## ADDENDUM | No. 1

PROJECT	<b>Madison Service Line – Segment 2/3A between Crooks and Colton, South Dakota</b>		
BID DATE	2:00 P.M.	Local Time - Central	April 26, 2022
BID LOCATION	Lewis & Clark Regional Water System Office 46986 Monty Street, Tea, SD 57064		
ISSUE DATE	4-19-22		
NOTICE	Failure to acknowledge all addenda in the BID may cause rejection of the BID. See Instructions to Bidders.

SHEET No.: 65

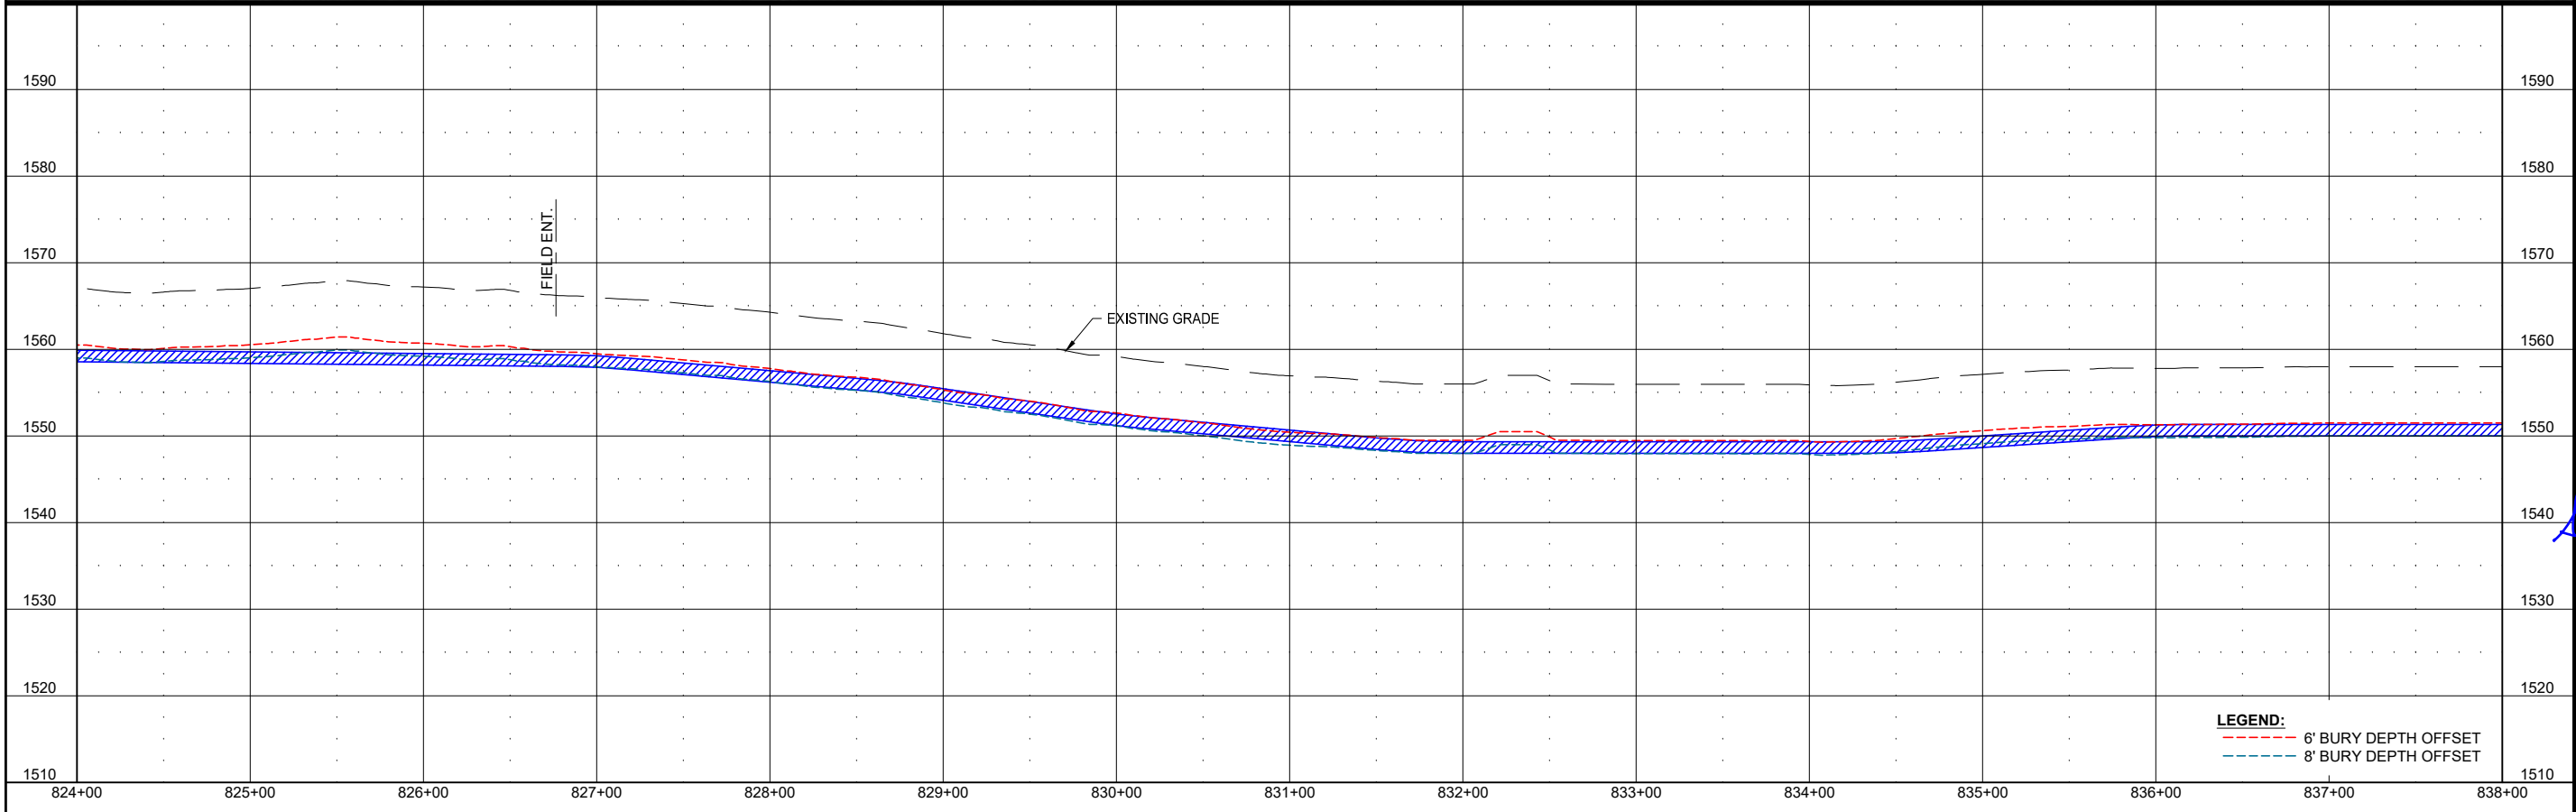
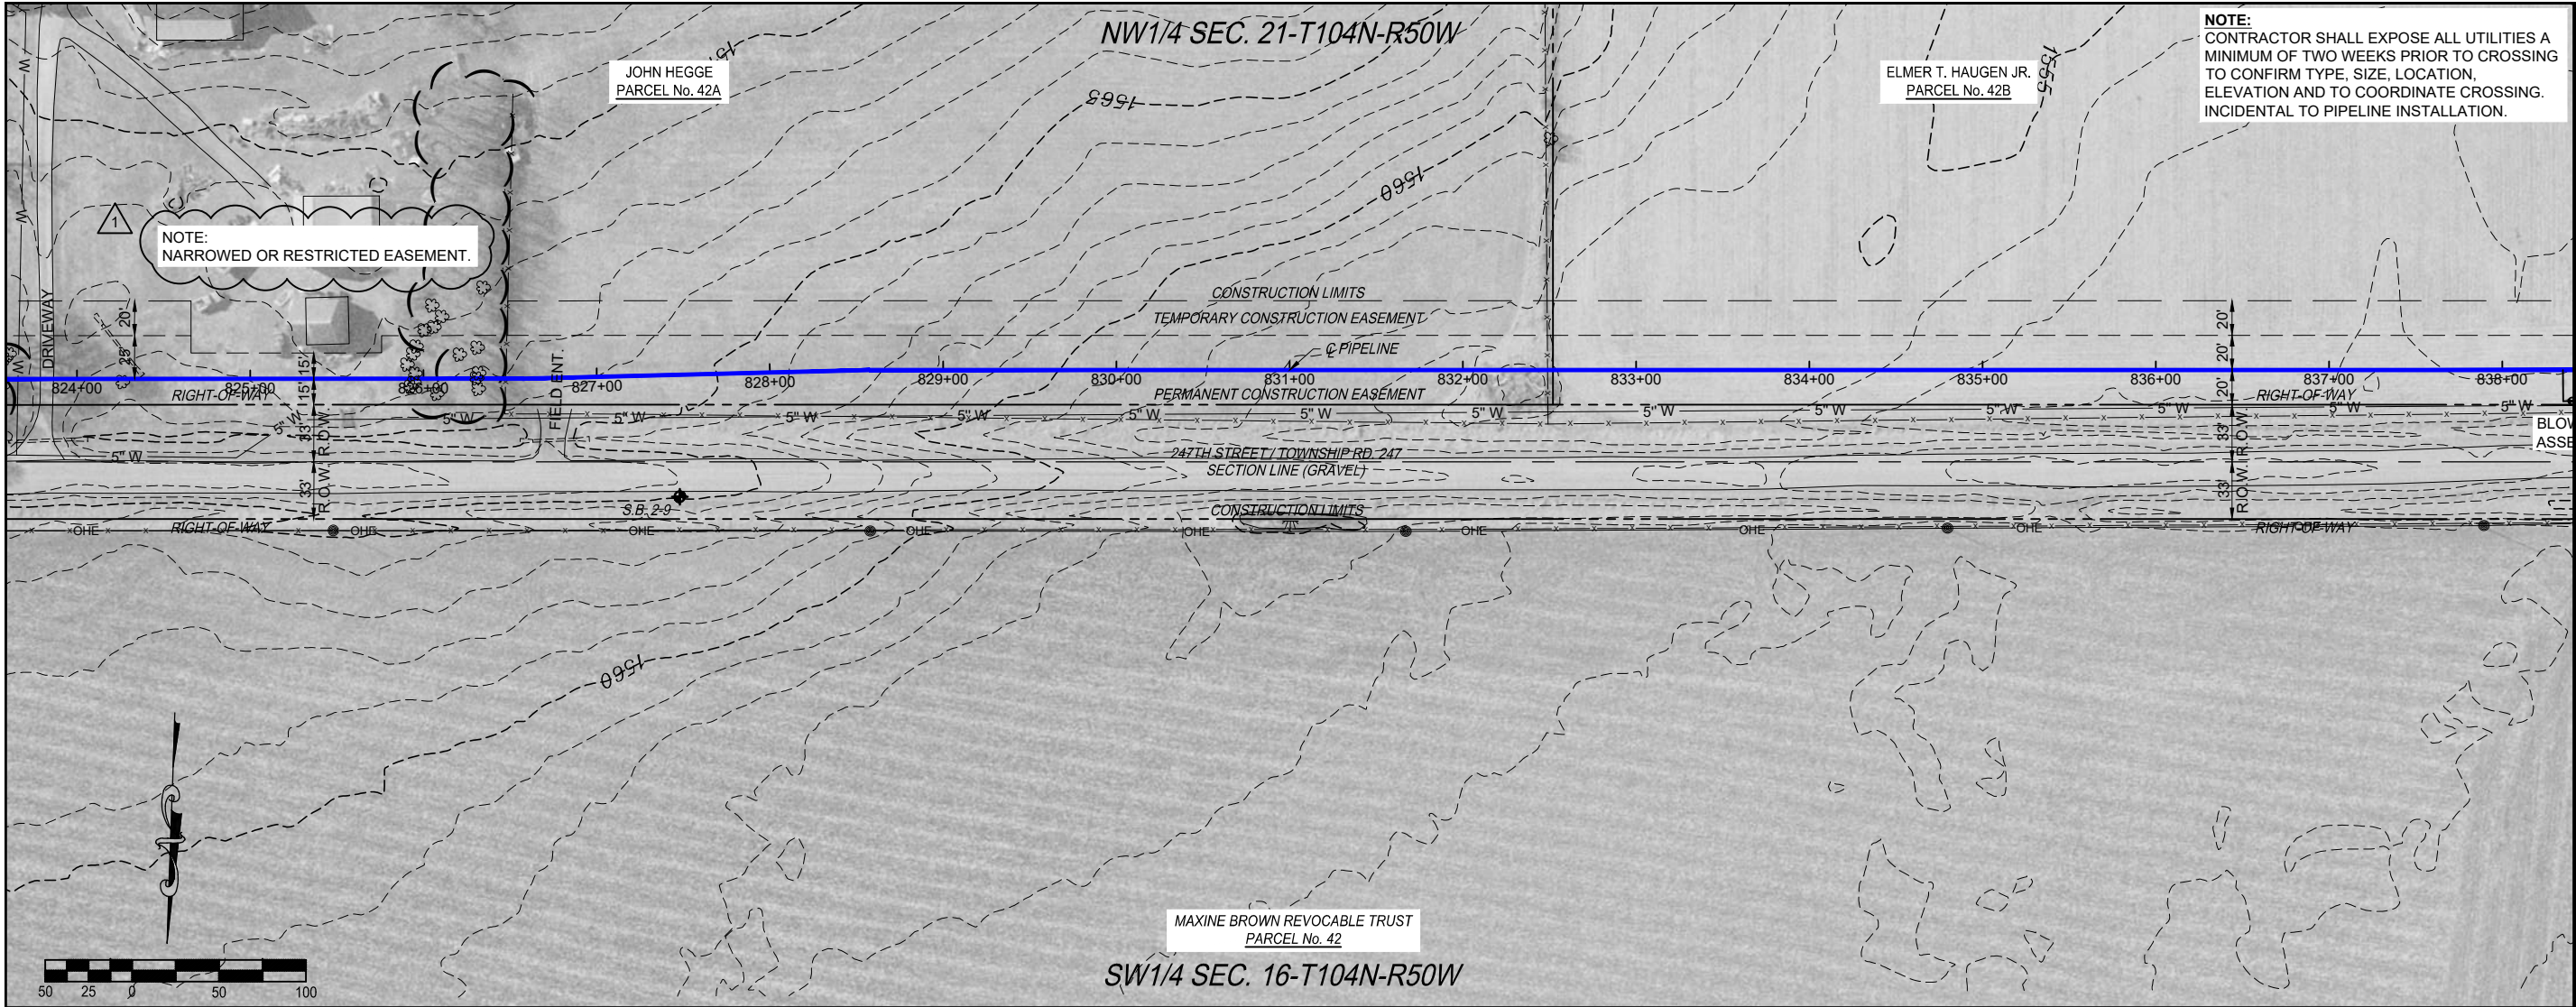
### Drawing Sheet 65.

DELETE the previous Sheet 65 dated 3-28-22, and REPLACE with the attached Sheet 65, Rev. No. 1 dated 4-19-22 in its place.

This drawing sheet has been added to call out narrowed easement.

87

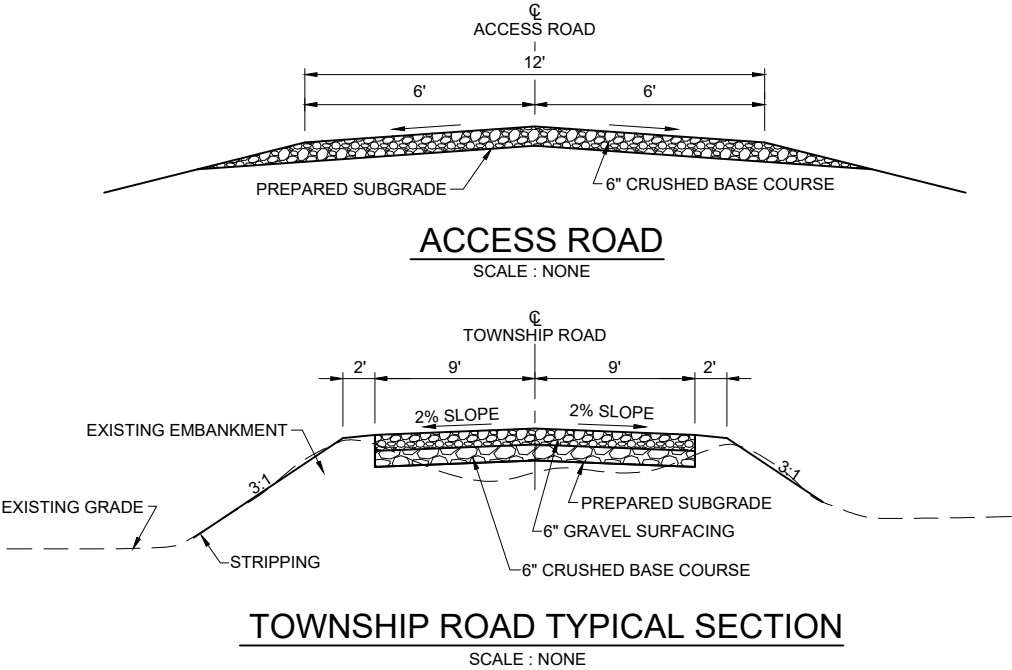
### Drawing Sheet 87.

DELETE the previous Sheet 87 dated 3-28-22, and REPLACE with the attached Sheet 87, Rev. No. 1 dated 4-19-22 in its place.

This drawing sheet has been added to remove the empty table.
